June 19, 2009

RE: Draft Montanore Project EIS – Review of the Hydrogeology and Water Resources Aspects of the Proposed Mining Project

This DEIS review focuses on hydrology and water resource issues. This review has been prepared on behalf of Save our Cabinets and Earthworks.

Figure 1: A portion of Figure 4 in Geomatrix (2006a).

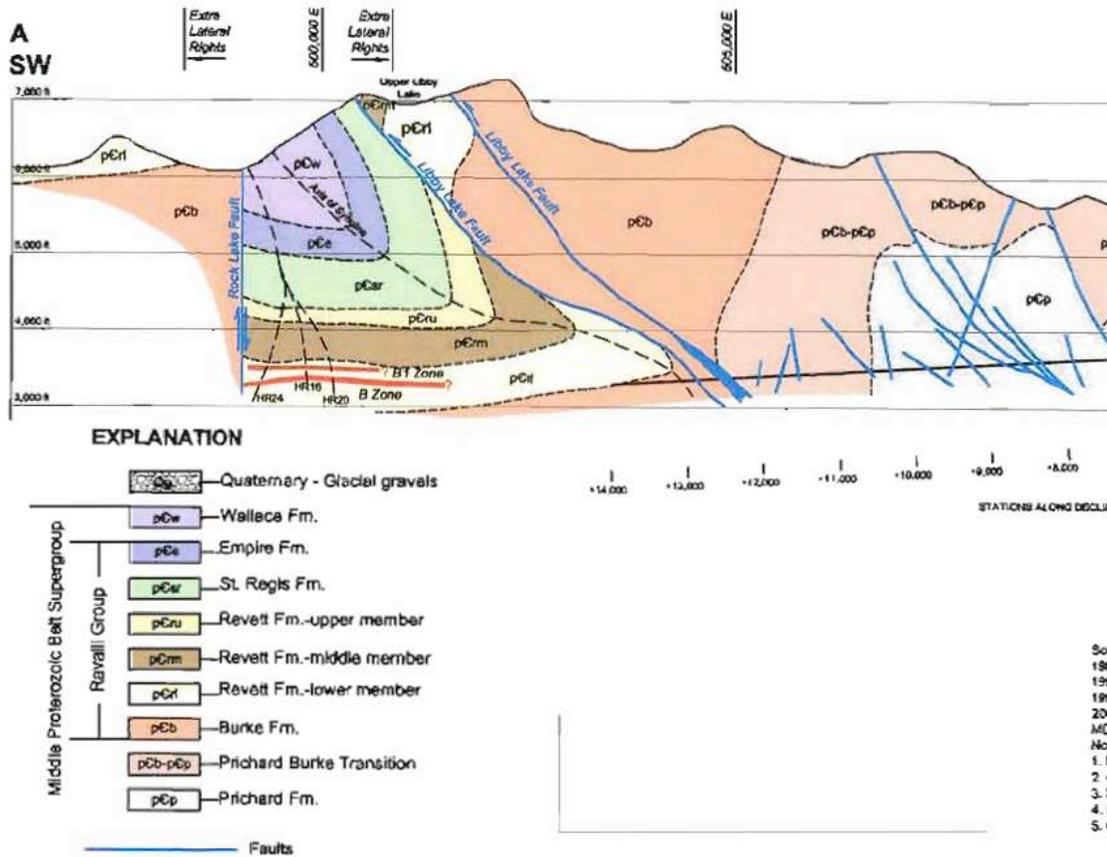
The mine and its drawdown will affect at least two fault systems, the Libby Lake and Rock Lake Faults. These should have been included in the conceptualization of the model. The speculative model testing of the effects of faults (ERO Resources, 2008) does not suffice for a proper conceptual model including the faults.
